# Access Compliance Report

## Public Rights-of-Way

### (Curb Ramps)

Intersection ID: 43137	Main Street: N_CHURCH_ST	Cross Street: W_30TH_ST	Location: NE
ADA ID: B4ECEC7996B2	Ramp Type: Perp	Initial Pass/Fail: Fail	Overall Compliance: No
Severity Score: 27.5			
Codes/Mitigation Info/Possible Solution		Field Measurements/Component Compliance

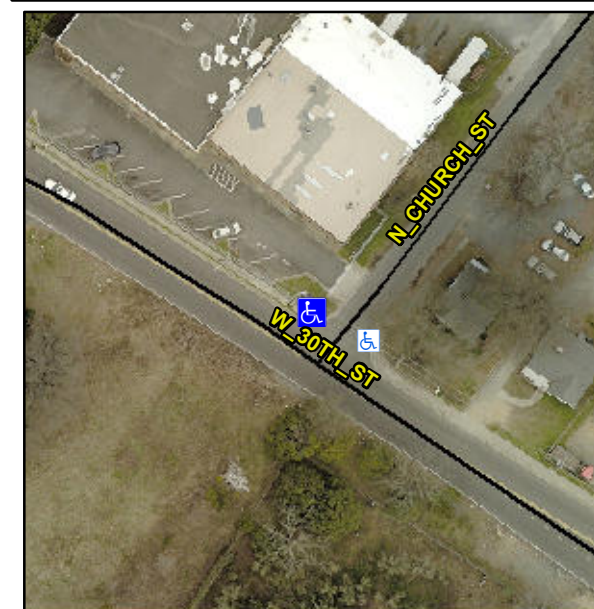
**Not Found, R304.2.2, R302.7**

Compliance	Description	Data	Compliance	Description	Data
N/A	Ramp Length (in)	22.5	No	Ramp Slope (%)	8.8
Yes	Ramp Width (in)	48.0	Yes	Ramp XSlope (%)	1.9
N/A	Flare Type LT	N/A	N/A	Flare Type RT	N/A
N/A	Flare Slope LT (%)	N/A	N/A	Flare Slope RT (%)	N/A
N/A	Flare Traversable LT?	N/A	N/A	Flare Traversable RT?	N/A
N/A	Landing Length (in)	N/A	N/A	DWS Provided?	N/A
N/A	Landing Width (in)	N/A	N/A	DWS Contrast?	N/A
N/A	Landing Slope (%)	N/A	N/A	DWS Length (in)	N/A
N/A	Landing X Slope (%)	N/A	N/A	DWS Full Width?	N/A
N/A	Landing Curb? (Y/N)	N/A	N/A	DWS Offset (in)	N/A
N/A	Shared Landing?	N/A			
N/A	Gutter Ponding?	N/A	N/A	Gutter Slope (%)	N/A
N/A	Gutter Lip Ht (in)	1.0	N/A	Gutter X Slope (%)	N/A
N/A	Painted X Walk1?	No	N/A	Painted X Walk2?	N/A
	X Walk 1 Direction	To SE		X Walk 2 Direction	N/A
N/A	X Walk 1 Width (in)	N/A	N/A	X Walk 2 Width (in)	N/A
	X Walk 1 Slope (%)	3.8		X Walk 2 Slope (%)	N/A
	X Walk 1 X Slope (%)	2.7		X Walk 2 X Slope (%)	N/A

N/A	Ramp inside XWalk1?	N/A	N/A	Ramp inside XWalk2?	N/A
	Road Slope (%)	N/A	N/A	Clear Space?	N/A
	Road X Slope (%)	N/A	N/A	Clear Space to XWalk (in)	N/A
N/A	Any Obstructions?	N/A	N/A	Storm Grate/Utility Hazard?	N/A
	Obstruction Type			Storm Grate/Utility Type	
		N/A			N/A
		No		Surface Condition? (G/P)	Poor

**Remove & Replace Entire Ramp.**
